**CITY OF AUSTIN**  
**Board of Adjustment/Sign Review Board**  
**Decision Sheet**

**CASE NUMBER: C15-2014-0163**

**ADDRESS: 1303 East 2ND ST**

## City of Austin Residential Permit Application Master Comment Report

FIGURE R602.10.1.1  
BRACED WALL LINES

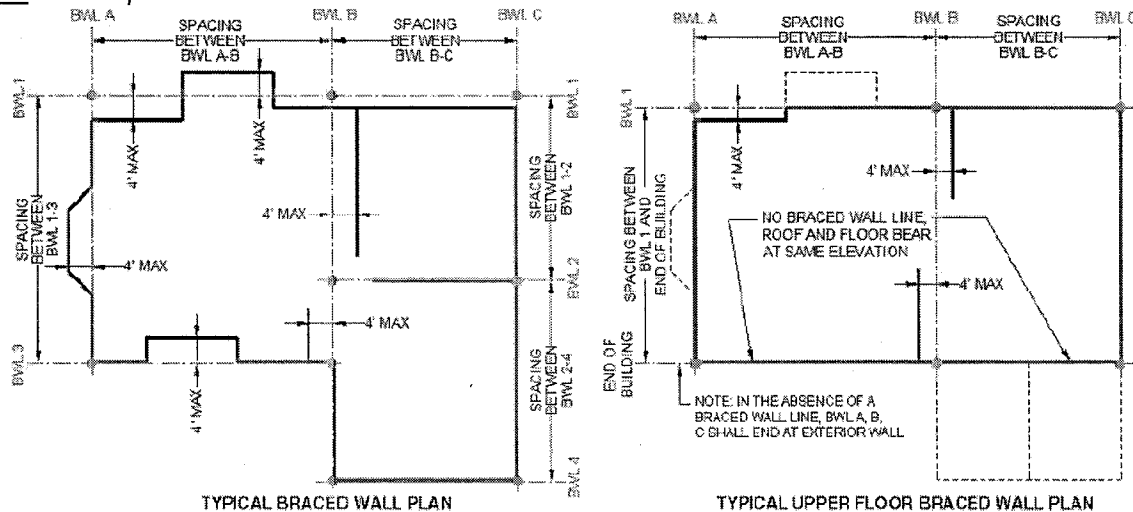
5. Roof structural plans required for new carport roof.
6. Submit brace wall plan stamped by engineer showing compliance with the currently adopted IRC. The plan shall **clearly indicate the braced wall lines** (Refer to IRC Figure R602.10.1.1 for sample showing BWL), the braced wall methods used, locations of the methods used at new and modified wall, and reference applicable details already provided. *General notes regarding continuous sheathing or references to code sections will not be accepted.*
